TTC-15050

Subject: Toyota Comments on Amendments to the LEV III Hybrid Electric Vehicle Test Procedures ("Second 15-Day Notice" of 9-Jun-2015)

Figure 4

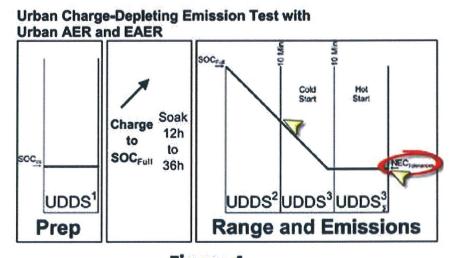
This start and end point is a carryover from HEV testing and cannot possibly be fulfilled in a charge-depleting test unless the engine turns on immediately at the beginning of the first cycle.

As shown by the two arrows indicating initial and final Amp-hr, even the example test shown in Section I Figure 4 does not fulfill this primary criterion. Additionally, the end point being identified as "NEC<sub>Tolerances</sub>", as opposed to "NEC<sub>Options</sub>", indicates that no additional end-of-test criteria may be used to validate this test.

Given that this test allows more than two cycles, the primary end-of-test criterion also ignores any cycles driven after the first two.

We propose that the primary end-of-test criterion be changed to apply over the last cycle or set of cycles, as described in p. A-50 paragraph 8 for compliance and in-use testing. This also follows the spirit of the end-of-test criteria described for charge-depleting tests in SAE J1711 sections 3.9 and 3.9.1, shown here:
